Design Review Board – Neighborhood Panel

Agenda Workshop

2:00 PM Tuesday, August 30th, 2022

Application by LUKE SIMS for a CERTIFICATE OF APPROPRIATENESS for a new residence at 211 West Earle Street (TM# 0008000400600)

Figure 1: 1920 Sanborn Map

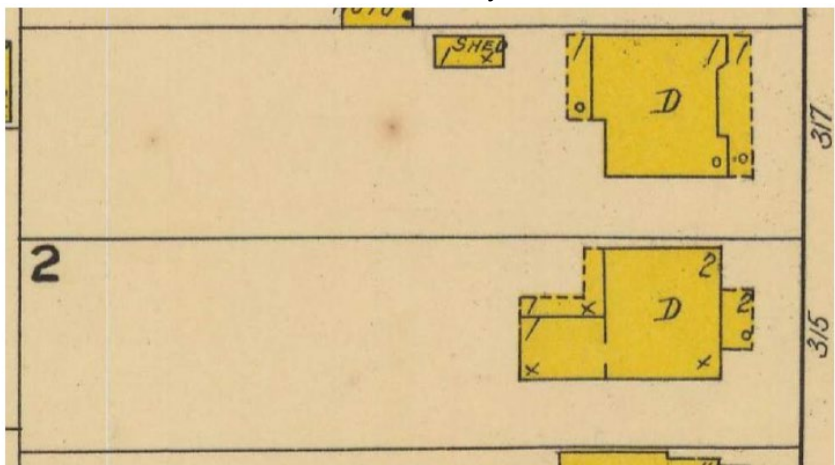
The applicant proposes to demolish the existing duplex, located at 215 W. Earle Street. The subject property is located within the National and Local Historic Col. Elias Earle Preservation Overlay District and was constructed c.1905, as documented in the City of Greenville's Historic Survey list. The existing home is listed as a contributing structure to the National Historic Register. The 1920 Sanborn Map records the existing home as shown. Note that addressing at the time started with the 100 block west of Main Street, while today addressing starts with the 000 block, therefor 215 West Earle is shown as 315 West Earle in the Sanborn Map:

1.0 Item 1(Picture)

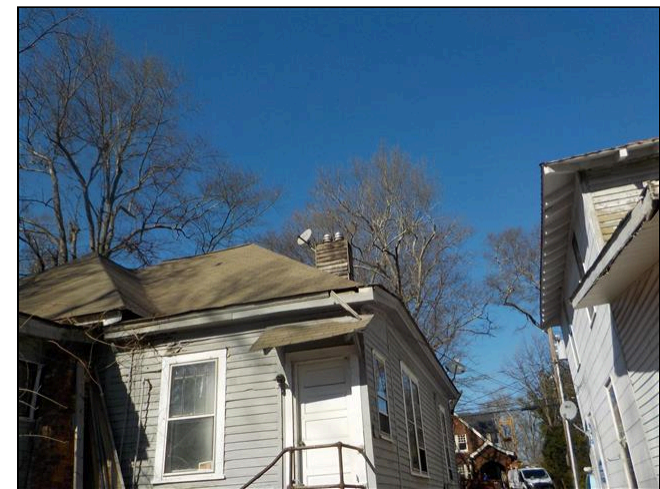
1.0 The roof covering is old, and the life of covering has expired. The covering does need to be replaced.

2.3 Item 1(Picture)

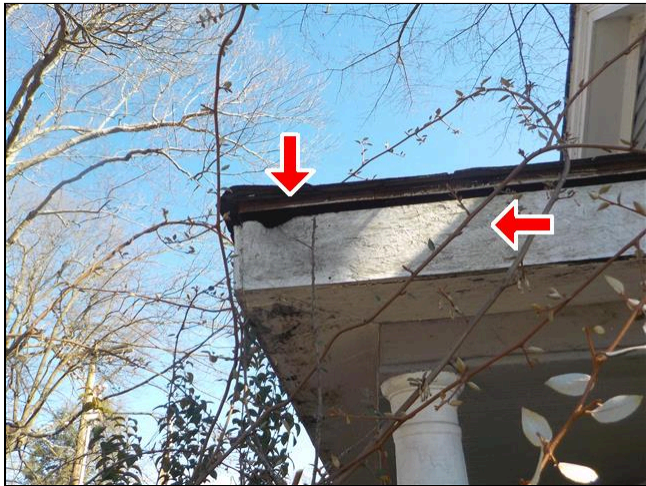
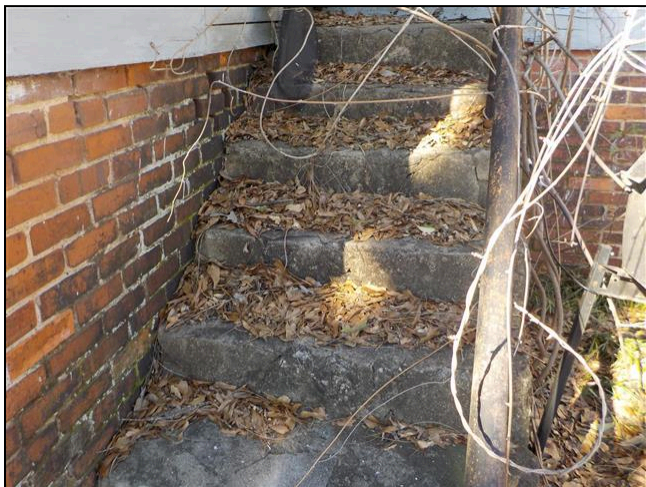
2.3 (1) Most of the front porch structure is covered. With the water that is dripping out of the roof and the way the porch is sagging there is a good possibility the front porch will need to be replaced. There has also been incorrect use of materials

7.5 Item 1(Picture)

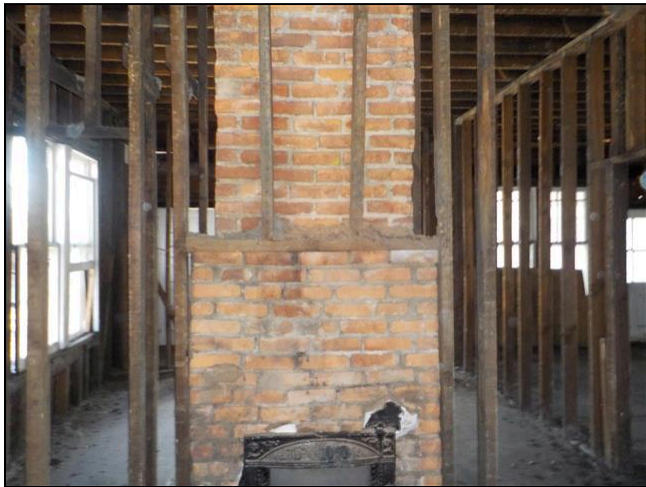
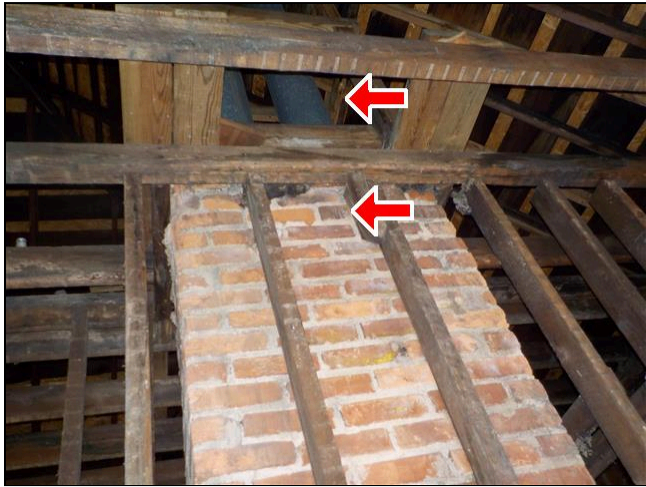
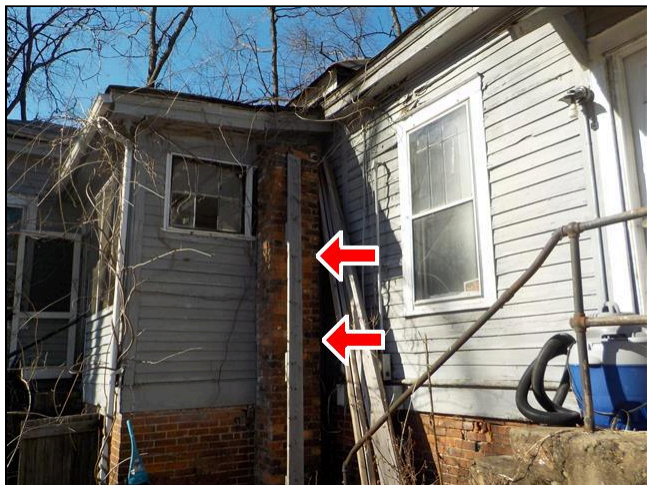
7.5 All chimneys are deteriorated and will need to be removed. The top has already been removed on one.

2.0 Item 1(Picture)

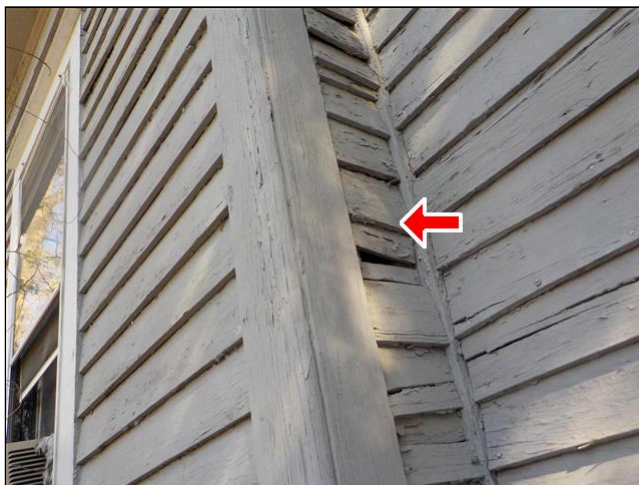
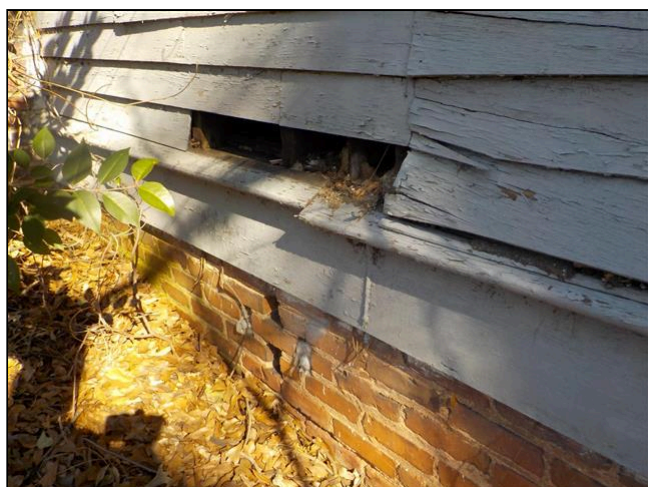
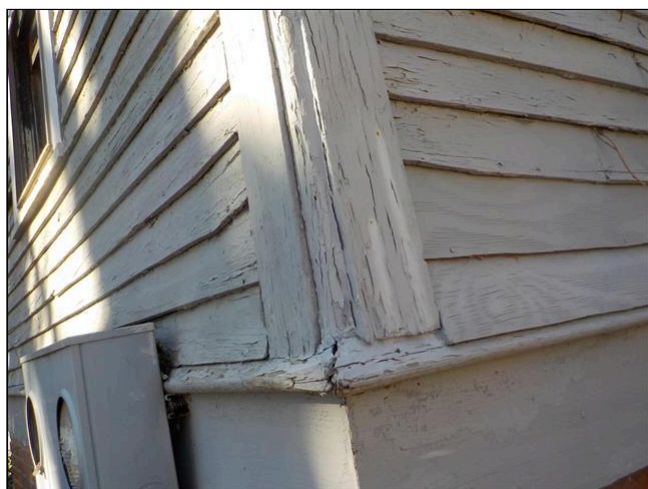
There are a good many areas the original siding is damaged . It may all need to be removed to repair the structure.

2.3 Item 1(Picture)

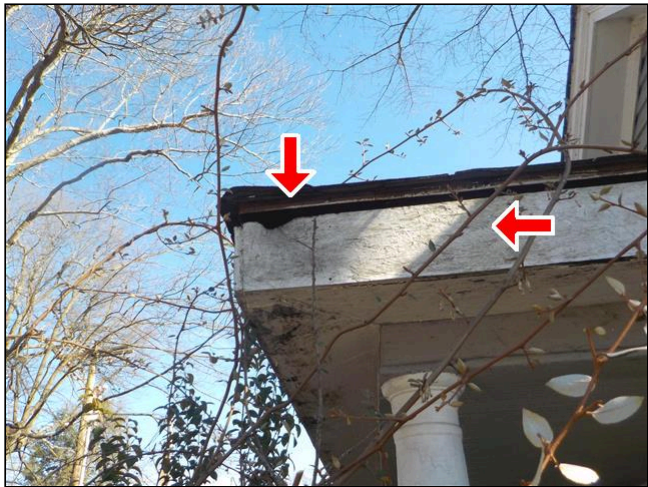
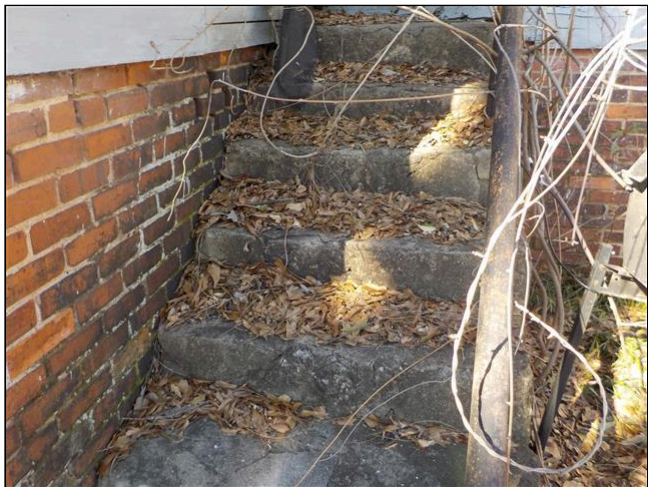
(1) Most of the front porch structure is covered. With the water that is dripping out of the roof and the way the porch is sagging there is a good possibility the front porch will need to be replaced. There has also been incorrect use of materials

3.2 Floors

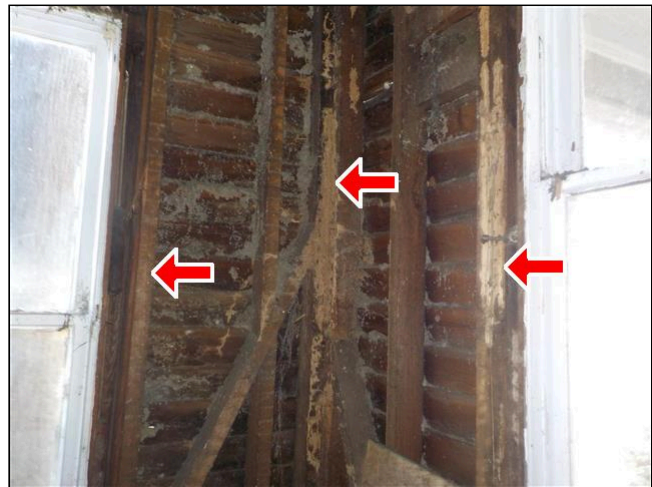
What's left of the hardwood floors will need to be replaced.

7.5 Item 1(Picture)

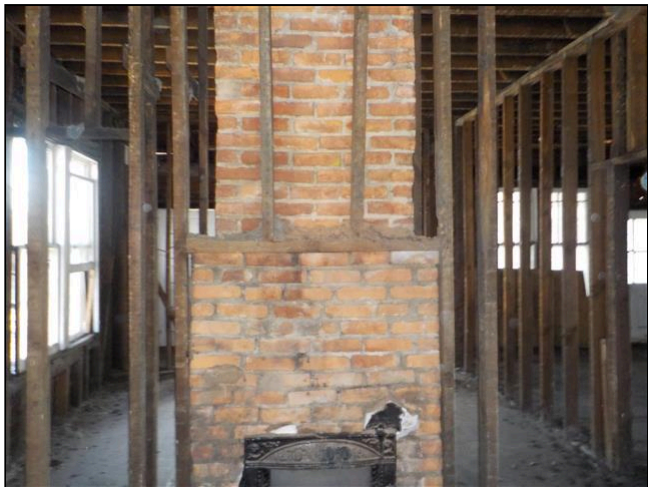
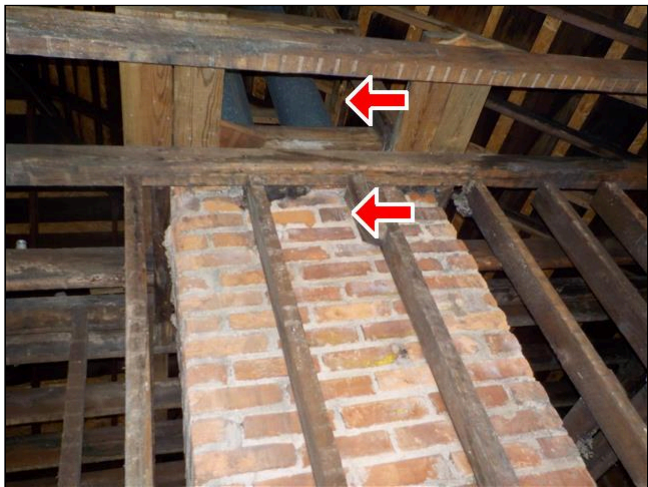
All chimneys are deteriorated and will need to be removed. The top has already been removed on one.

PHOTO #1

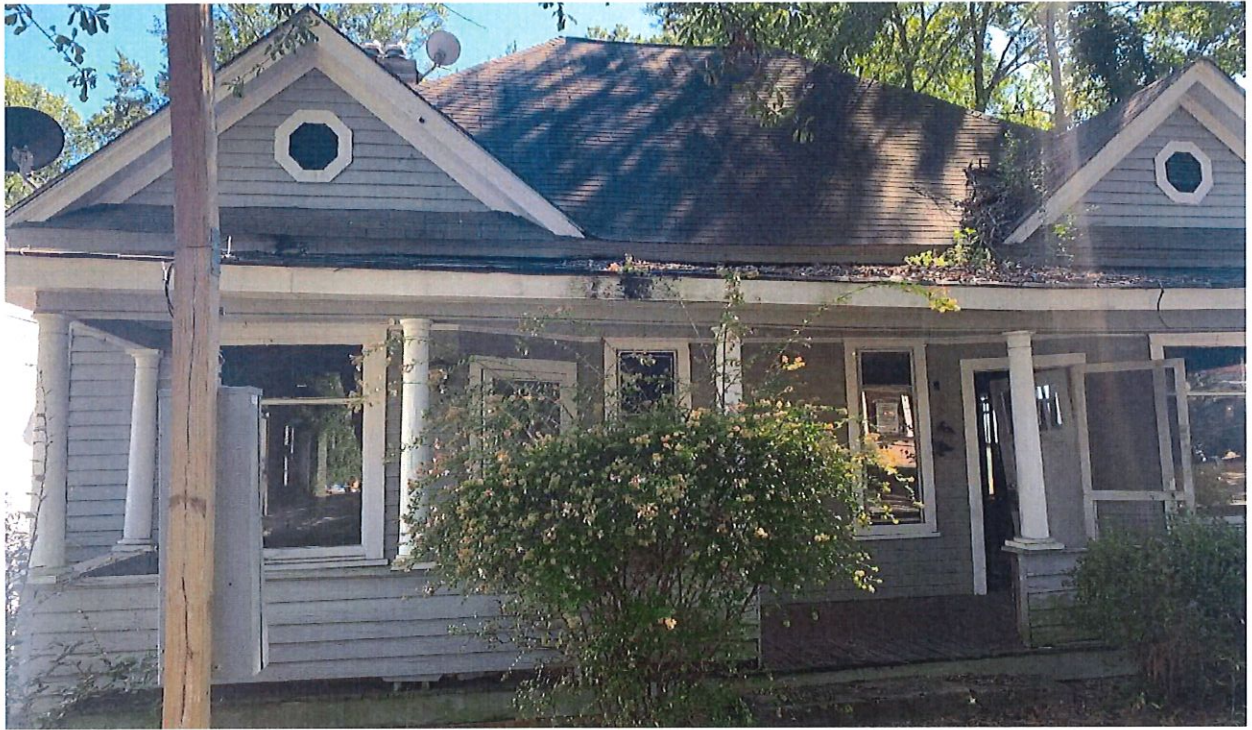
1. The referenced house is a one-story wood framed structure with a brick pier and curtain wall foundation. From information provided, we think the building was constructed circa 1900's (see photo #1). It is our understanding that you plan to add a second floor to the existing structure if feasible.
